Informal document No.
80th GRSG, 2-6 April 2001,
agenda item 6.

PROPOSAL FOR DRAFT AMENDMENTS TO REGULATION No. 43
(Safety glazing)

Transmitted by the Experts from Belgium and the United Kingdom

"Rigid plastic glazing [~~other than windscreens~~]

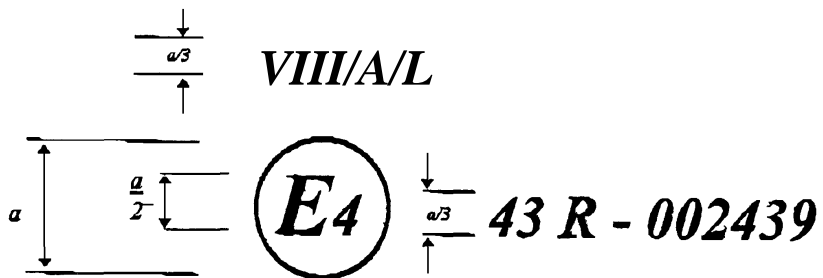
The approval mark example for rigid plastic glazings other than windscreens, amend to read:

The above approval mark affixed to a rigid plastic glazing pane for forward facing panels shows that the component concerned has been approved in the Netherlands (E 4) pursuant to Regulation No. 43 under approval No. 002439. The approval number indicates that the approval was granted in accordance with the requirements of Regulation No. 43 in its original form. The pane has been abrasion tested so that the outer surface meets the 2 per cent light scatter/1000 cycle requirement and the inner surface meets the 4 per cent light scatter/100 cycle requirement."

ii) It is redundant to make a link to windscreens, hence the text may be simplified. Regarding rigid plastic glazing, an additional exchange of opinions is needed, therefore, brackets have been added.

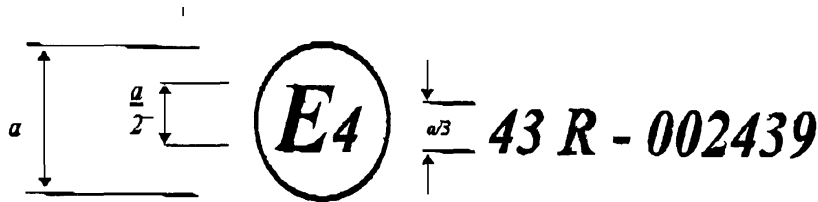
Add the following footnote

1/ In the case of plastic panes, additional symbols must be combined within the approval marking.

iii) The addition of a footnote is needed to underline the fact that the markings V, A/L and the other ones must be combined in the case of plastic panes. Therefore, the addition of examples of markings will not be necessary.
